December 16, 2015
BOARD OF COUNTY COMMISSIONERS
ORANGE COUNTY, FLORIDA
Addendum No. 3, IFB Y16-718-CC

MILDRED DIXON ACTIVITY CENTER HVAC REPLACEMENT

Orange County Mildred Dixon Activity Center HVAC Replacement

A ELECTRICAL - NEW WORK PLAN
SCALE: 1/4" = 1'-0"

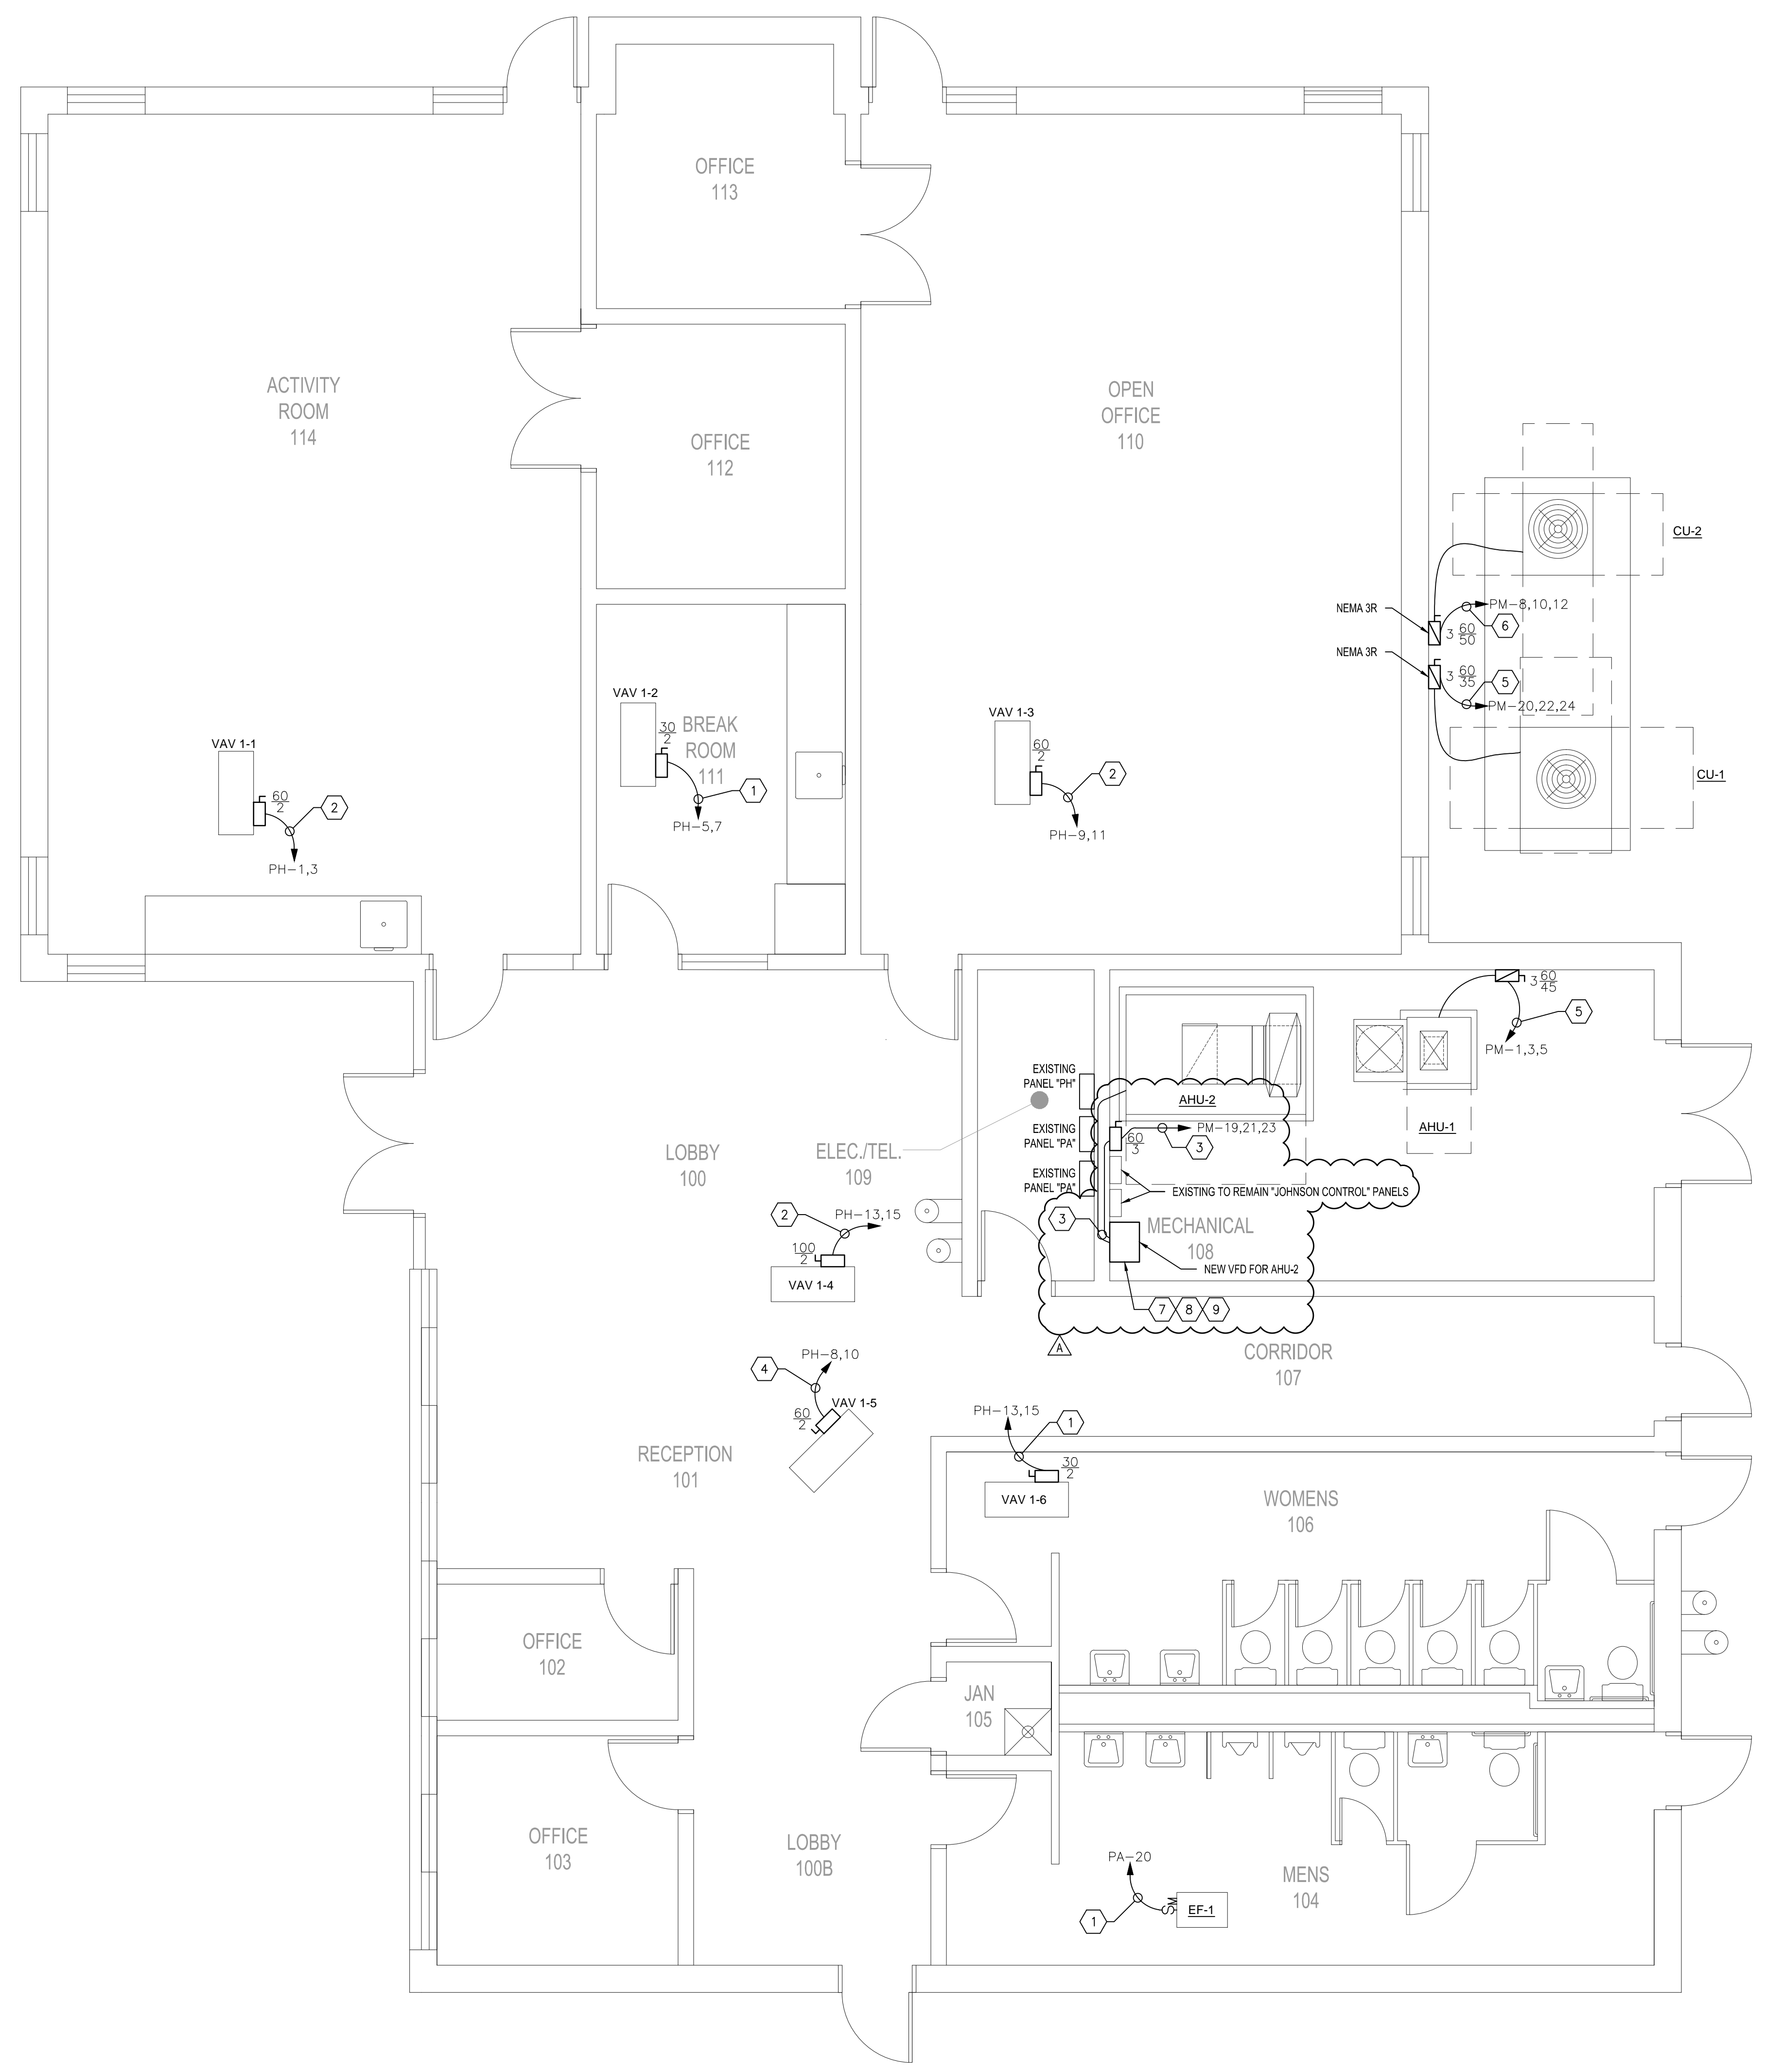
Sheet	Description of Revision
M-001	-Added HVAC General Note #20
M-101	-Revised Key Note #7 -Located existing VFD to be replaced
M-102	-Revised Key Note #5 -Revised condensate lines to be two lines, one per AHU -Located new VFD to be provided
M-201	-Added Variable Frequency Drive to note #6 -Added note #8 to Split DX Indoor AHU Schedule -Revised Detail #4 for above ground refrigerant piping
E-101	-Added new Variable Frequency Drive to Key Note #7 and located new VFD and disconnect to electrical plan -Added Key Note #8 for HOA VFD control - Added Key Note #9 for new VFD coordination with existing building management system (Johnson Controls)

- NEW 2#12 & 1#12G IN EXISTING 3/4" CONDUIT.
- NEW 2#6 & 1#10G IN EXISTING 3/4" CONDUIT.
- NEW 4#4 & 1#10G IN NEW 1 1/4" CONDUIT.
- NEW 2#6 & 1#10G IN EXISTING 3/4" CONDUIT.
- NEW 3#6 & 1#10G IN NEW 1" CONDUIT.
- NEW 4#4 & 1#6G IN EXISTING 1" CONDUIT.
- NEW VFD WITH BY-PASS 200V, 3- ϕ , MANUFACTURER: ABB CATALOG NO.: ACH550-B0R-017A-2-800547267 DIMENSIONS: 36.1" x 20.5" x 15.3" (H x W x D)
- PROVIDE A HAND-OFF-AUTO SWITCH IN FRONT COVER OF THE NEW NEMA-12 VFD ENCLOSURE.
- COORDINATE REPLACEMENT OF VFD WITH OWNER AND EXISTING BUILDING MANAGEMENT SYSTEM (JOHNSON CONTROL PANEL) REQUIREMENTS. CONTRACTOR TO PROVIDE AND ROUTE NEW CONTROL WIRING AND CONDUIT FROM VFD TO JOHNSON CONTROL PANEL AS REQUIRED FOR A COMPLETE AND FUNCTIONAL WORKING SYSTEM.
